Attachment 1

GEOTECHNICAL CRITIQUE
PALISADES LANDMARK CONDOMINIUM PROJECT DRAFT EIR
 ENV-2000-2696-EIR; SCH 2002051086; January 2003
 (re Vesting Tentative Tract #52928)
 E.D. Michael
 March 31, 2003

Figure 1. Revello Drive Landslide in Relation to the PLC Project.
 The dashed line is the contact of the Revello Drive landslide from DEIR Figure IV.D-1. It is superimposed over DEIR Figure III-1. The slide movement is to the southeast.

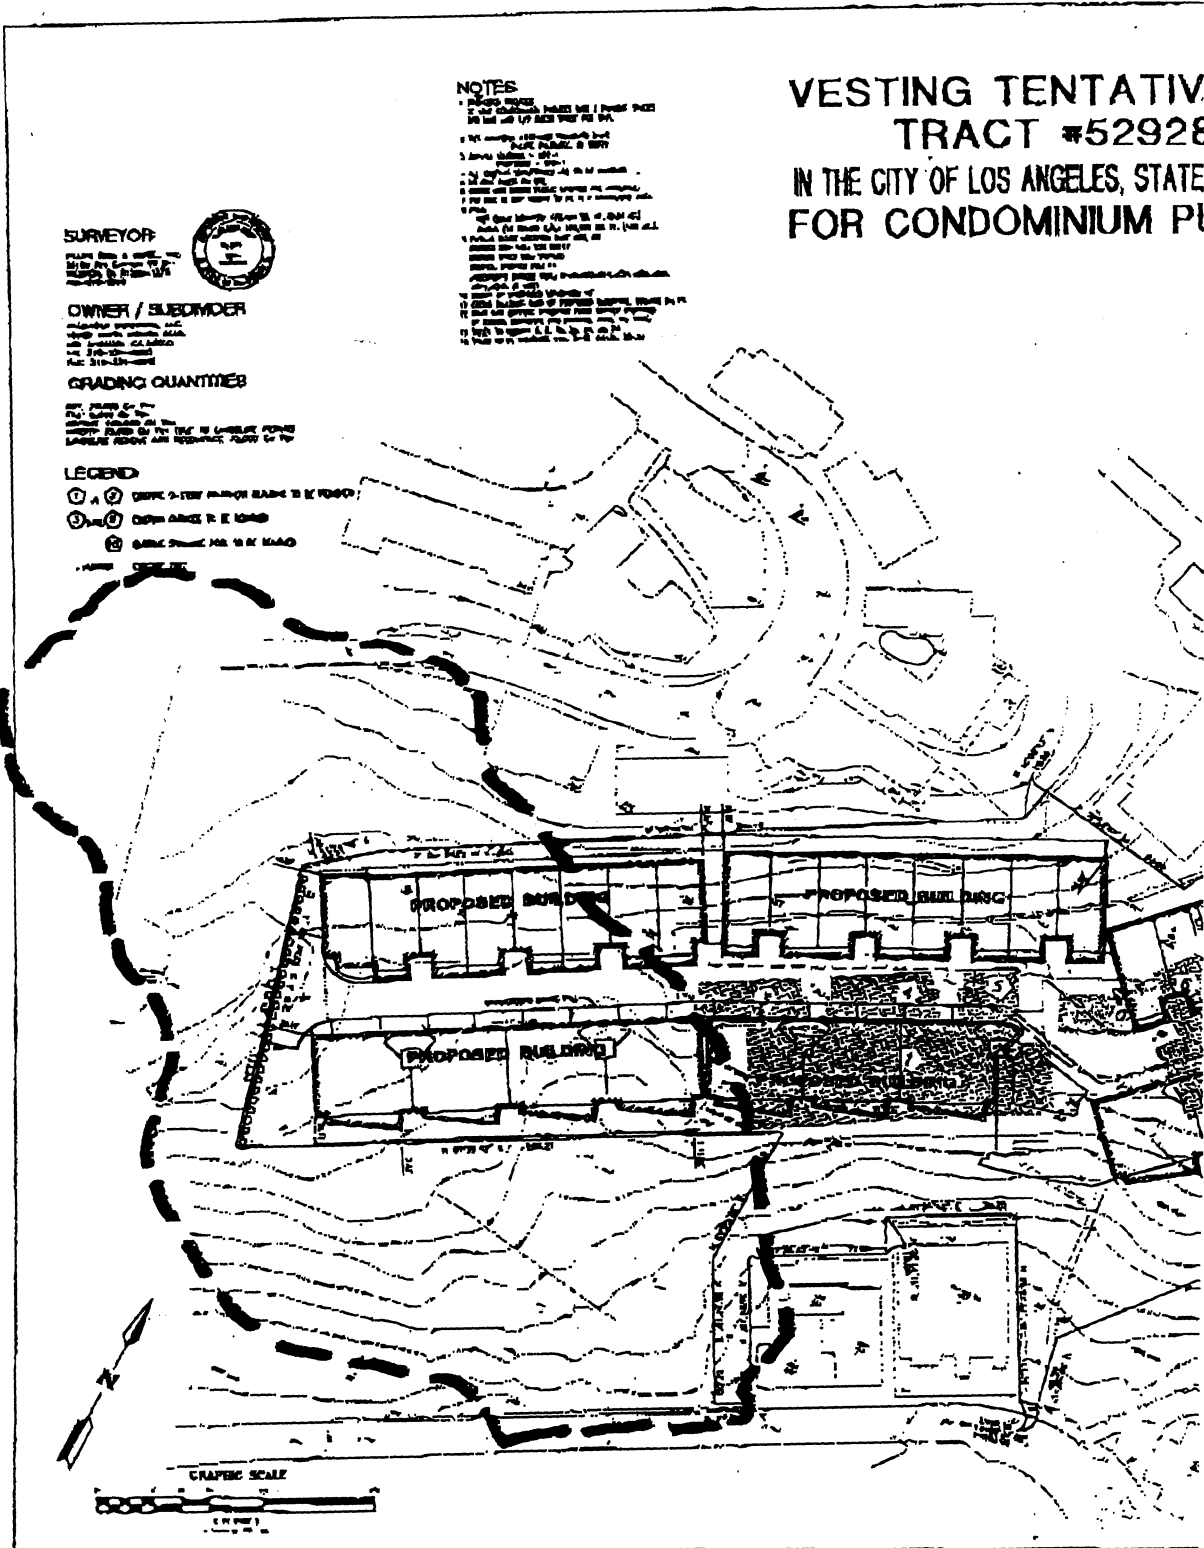
Reference [1, pp. 18 - 19] indicates that stabilization of Revello Drive landslide debris within the area of the PLC Project requires the installation of at least the northern (up-slope) line of soldier piles and the western line as well prior to excavation of the landslide debris. It appears that the southern line would be of less concern because of a deep depression there due to secondary landsliding within the main mass largely or entirely within the GHP property. Eventually, the lower line of piles would be required "... to support the future compacted fill along the downslope property line." However, that lower line is the northern boundary of the GHP development that will have retaining walls "... which will be the full height of the slide" [*ibid.*].

The fill that is to replace the landslide debris is to be installed within the upper and lower lines of soldier piles at some depth below the existing slide surface. Figure 1 indicates relationships of the PLC Project to the Revello Drive landslide. The area of the debris mass within the PLC boundaries is roughly 40,000 square feet (sf) based upon the small-scale geologic map included in the DEIR documents (DEIR, Fig. IV.D-1; DEIR App I, [1]). The side contacts of the debris mass have been found by subsurface exploration to be nearly vertical [2, p. 2, Item 3]. Since the postulated volume of debris is 70,000 cubic yards (cy), i.e., 1,890,000 cubic feet, the average depth of the slide debris must be about 47 feet. However, "... removal depths could be up to 60 feet..." [1, p. 20].

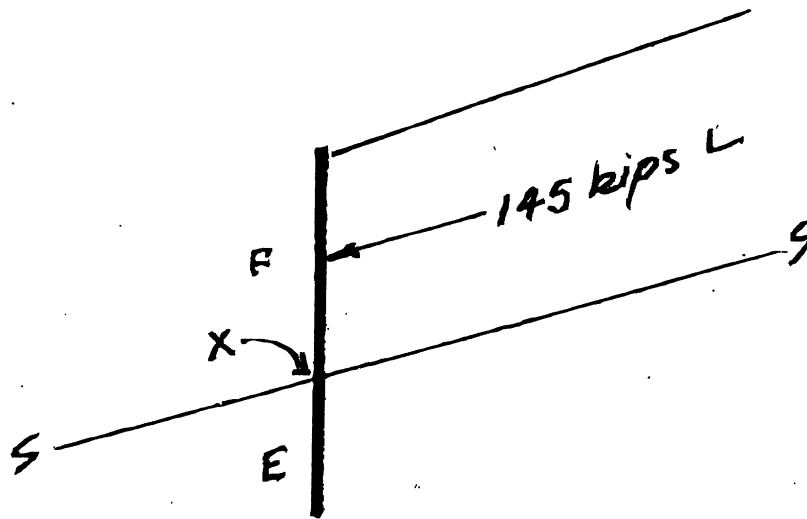
The design loads that the landslide debris will exert on pilings 1 - 30 prior to installation of the replacement fill will range from 145 to 175 kips (1 kip = 1,000 pounds) [1, p. 20; 2, p. 7]. An embedment depth of "... 20 feet into bedrock below the 1½: 1 setback plane..." [3, Item 1, Item 11, p. 2] apparently is meant to apply to pilings 31-40 which will support bedrock [2, Item 11, p. 7]. However, based upon Cross-sections A-A, B-B, and C-C [2], all of which pass through the landslide debris, it appears that pilings 1 - 30 will be about 60 feet deep and extend a revised 20 feet into bedrock as well. A fair model of the geometry these data appear to represent is shown in Figure 2.

A serious question to be examined is whether the free-standing piles along the northern PLC Project boundary will stand during the period when the landslide debris has been removed and replacement fill not yet installed. The over-turning moment represented by Figure 1 needs to be considered. The initial question in this regard seems to be whether resistance offered to the buried 20-foot pile section due to the strength of the bedrock is greater than over-turning moment due to the 145- kip per foot of landslide debris force acting at the centroid of the exposed pile section.
